Business Park
Plot J2

DESIGN RESPONSE STATEMENT

2022-052-DOC_04 ISSUE NUMBER: P03

On 16th February, Rochdale Borough Council's Planning Committee considered a planning application submitted by Wilson Bowden Developments Ltd. The application (22/01200/FUL) was a full application for the 'Erection of two industrial/warehouses (Classes E(g) (iii), B2 and B8) with ancillary office space, new access, car parking, servicing, boundary treatments, hard and soft landscaping and other associated works.

Section D-D

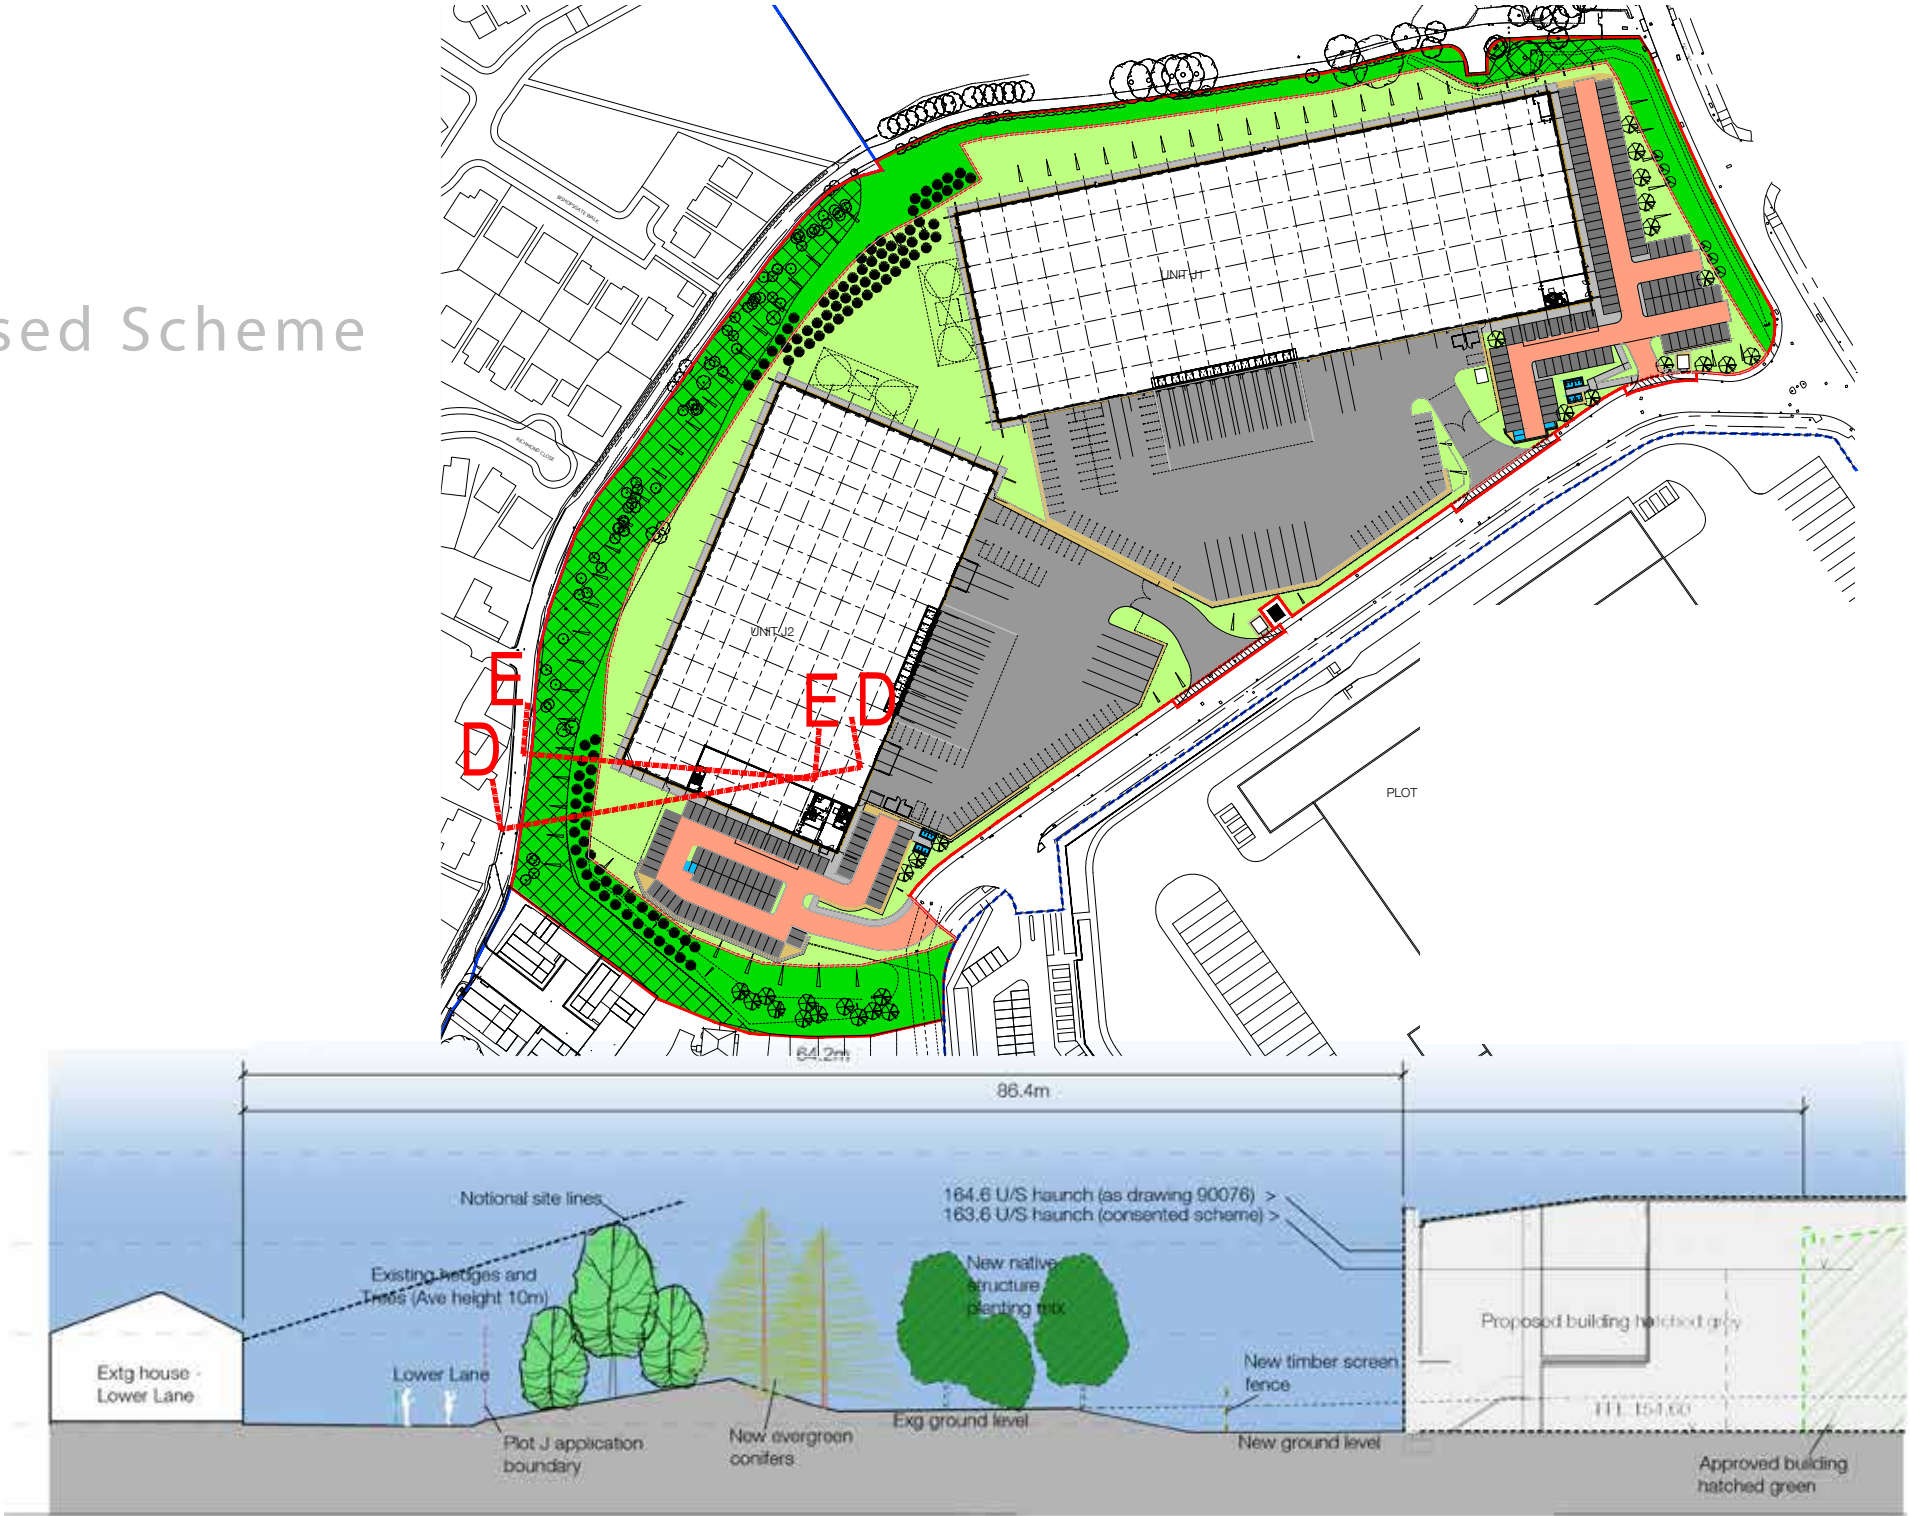
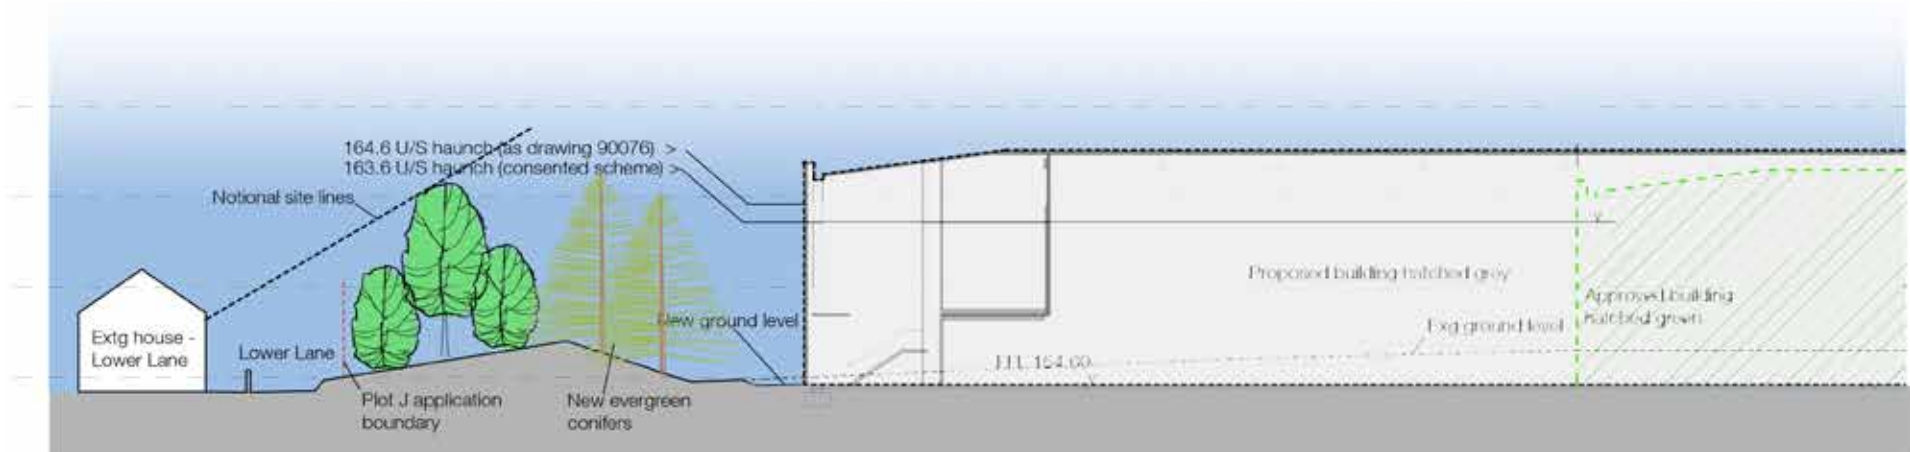
- The residents representatives felt Tithe Barn and Lower Tithe would be most impacted by the previous Unit J2 car park and building corner
- This revision allows for an increased depth of the landscaped buffer between Unit J2 car park, Tithe Barn and Lower Tithe - Please refer to Site Sections D-D and E-E

- We noted the negative comments regarding the introduction of a close boarded timber fence along the boundary and top of bund. The residents representative felt this would create a sense of becoming “fenced in”

- Unit J2 car parking is replanned by shortening the length but increasing the width. The revision to the car park has reduced the overall length of the car park by 15.6m

- We can confirm that Tithe Barn was the closest dwelling to the previous car park layout at 33m. The closest dwelling on the revised scheme is Lower Tithe with 47m between the dwelling and car parking

- With the reduction in the overall car park length we still propose to introduce a close boarded timber fence to provide a physical barrier between the car park and residents however this is no longer located on the boundary or top of bund

- The newly introduced 2.4m high close boarded timber fence is now proposed to be located on the back edge of the car park. This moves the proposed fence line a considerable distance further away from Tithe Barn and Lower Tithe whilst still offering screening from headlights and helping with noise reduction

- In order to further screen the corner of Unit J2 from Tithe Barn and Lower Tithe, we are now proposing to introduce mature evergreen structure planting within the site boundary

- As such, further mature evergreen planting is proposed to be implemented in this area in order to offer year round screening and close the gap along the rear of Unit J1 and J2
